Access Compliance Report

Public Rights-of-Way

(Curb Ramps)

Intersection ID: 10019902	Main Street: ARCO_CORPORATE_DR	Cross Street: N/A	Location: NE
ADA ID: 2D7190731970	Ramp Type: PerpDiag	Initial Pass/Fail: Fail	Overall Compliance: No
Codes/Mitigation Info/Possible Solution		Field Measurements/Component Compliance

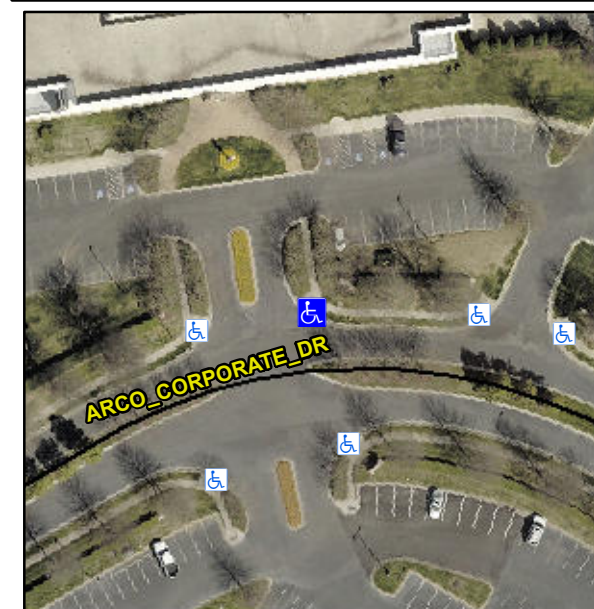
Not Found, R304.5.1

Compliance	Description	Data	Compliance	Description	Data
N/A	Ramp Length (in)	55.0	Yes	Ramp Slope (%)	7.3
No	Ramp Width (in)	36.0	Yes	Ramp XSlope (%)	3.5
N/A	Flare Type LT	N/A	N/A	Flare Type RT	N/A
N/A	Flare Slope LT (%)	N/A	N/A	Flare Slope RT (%)	N/A
N/A	Flare Traversable LT?	N/A	N/A	Flare Traversable RT?	N/A
N/A	Landing Length (in)	N/A	N/A	DWS Provided?	N/A
N/A	Landing Width (in)	N/A	N/A	DWS Contrast?	N/A
N/A	Landing Slope (%)	N/A	N/A	DWS Length (in)	N/A
N/A	Landing X Slope (%)	N/A	N/A	DWS Full Width?	N/A
N/A	Landing Curb? (Y/N)	N/A	N/A	DWS Offset (in)	N/A
N/A	Shared Landing?	N/A			
N/A	Gutter Ponding?	N/A	N/A	Gutter Slope (%)	N/A
N/A	Gutter Lip Ht (in)	N/A	N/A	Gutter X Slope (%)	N/A
N/A	Painted X Walk1?	No	N/A	Painted X Walk2?	No
	X Walk 1 Direction	To W		X Walk 2 Direction	To S
N/A	X Walk 1 Width (in)	N/A	N/A	X Walk 2 Width (in)	N/A
	X Walk 1 Slope (%)	1.9		X Walk 2 Slope (%)	2.8
	X Walk 1 X Slope (%)	3.3		X Walk 2 X Slope (%)	5.0

Remove & Replace Curb Ramp With Two New Directional Ramps or Equivalent.
